**MAJOR PROJECT ASSESSMENT:
Concept Plan and Stage 1 Project
Application at the Shepherd's Bay
Foreshore, Meadowbank and Ryde
(MP09_0216 and MP09_0219)**

Director-General's
Environmental Assessment Report
Section 75I of the
Environmental Planning and Assessment Act 1979

December 2012

Figure 32: Indicative Accessible Circulation Plan (Source: Proponent's PPR)

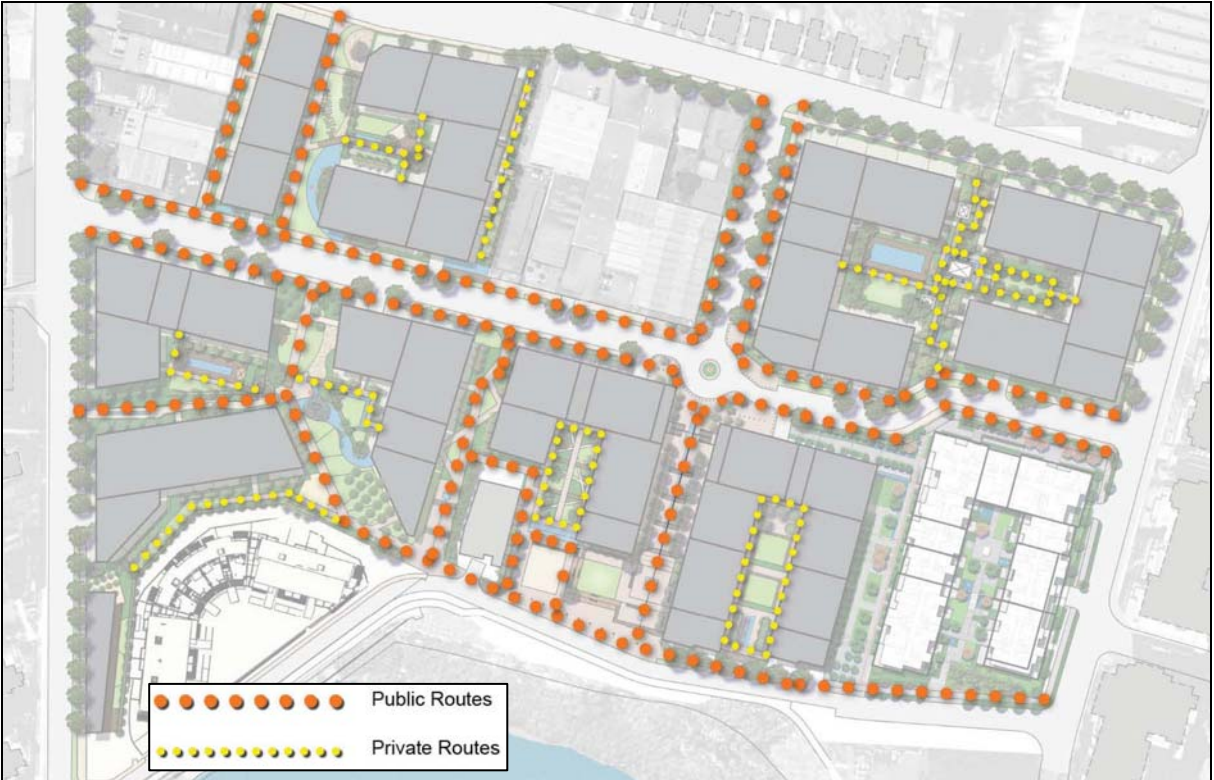
While the Pedestrian and Cycle Access Plan (**Figure 30**) does not indicate that pedestrian paths will be provided along both sides of Nancarrow Avenue and Hamilton Crescent, the Accessible Circulation plan does (see **Figure 31**). However, no accessible pathways are indicated along Bowden Street, Constitution Road, or Belmore Street. The department considers that it is essential for a development of this density to provide pedestrian pathways accessible for all persons on both sides of the street within all road reserves adjacent to the development.

Figure 33: Landscape Masterplan indicating some of the open space areas (Base Image Source: Proponent's PPR)

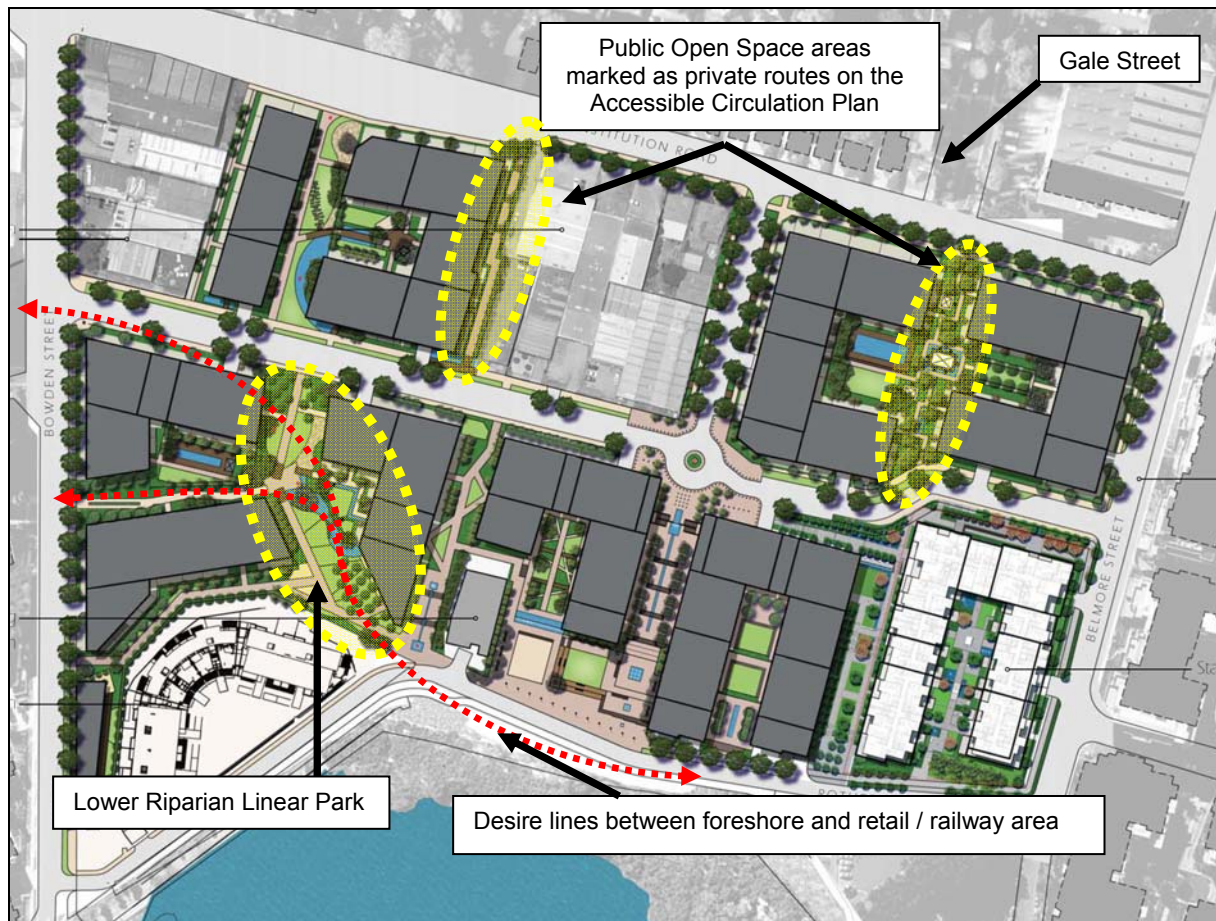
Although the landscaped areas between Stages 2 and 4 and to the east of Stage 8 are indicated as being private access routes on the Indicative Accessible Circulation Plan, this plan is inconsistent with the proponent's publically accessible open space area calculations which includes these areas (refer to **Figure 37** in **Section 5.7**) and with the information within the proponent's statement of commitments which indicates that the areas are designated as publically accessible open space. The amount of public open space provided under the proposal, inclusive of these two access routes, is already below the existing rate of open space provision in the Ryde LGA (refer to discussion in **Section 5.7**). As such, the department considers that these areas should not be deleted from the public open space provision. A future assessment requirement is recommended to ensure these areas are provided as public access routes, and therefore address Council's concerns in relation to pedestrian connections from Gale Street to the foreshore.

Figure 42: Extract from proposed landscape plan (Base Image Source: Proponent's PPR)

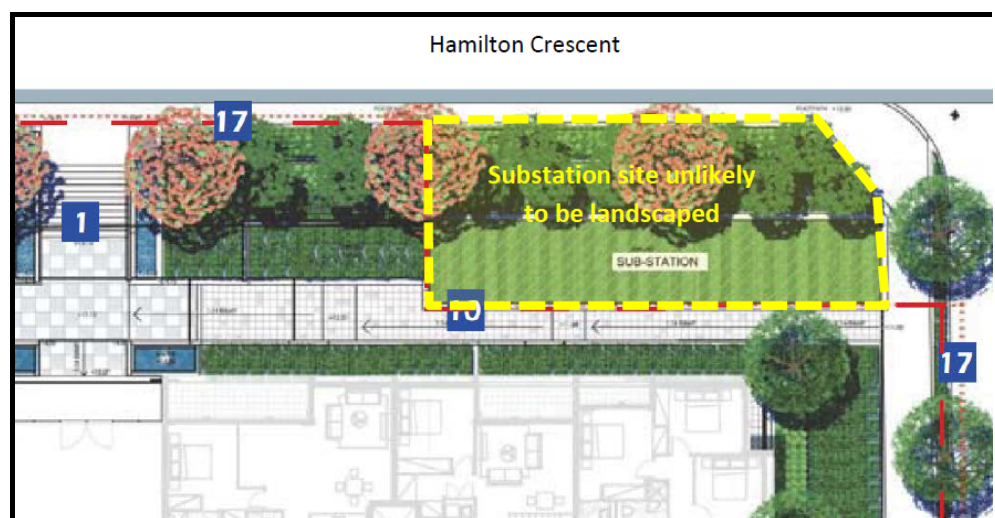
Landscape plans submitted with the application indicate planting in this area, but the land is outside of the site boundary and no owners consent has been provided by Ausgrid for the works. The proposed landscaping is therefore unlikely to be provided, resulting in adverse streetscape impacts from the substation as well as the proposed building.

A condition requiring either landscaping of the substation site in consultation with Ausgrid or otherwise updated landscape plans providing landscape screening by way of planting within the public domain and on the subject site is recommended. As the screening would involve planting on Council land, the details will need to be provided to Council for approval in conjunction with public domain landscape plans required as discussed in **Section 5.2.2**.
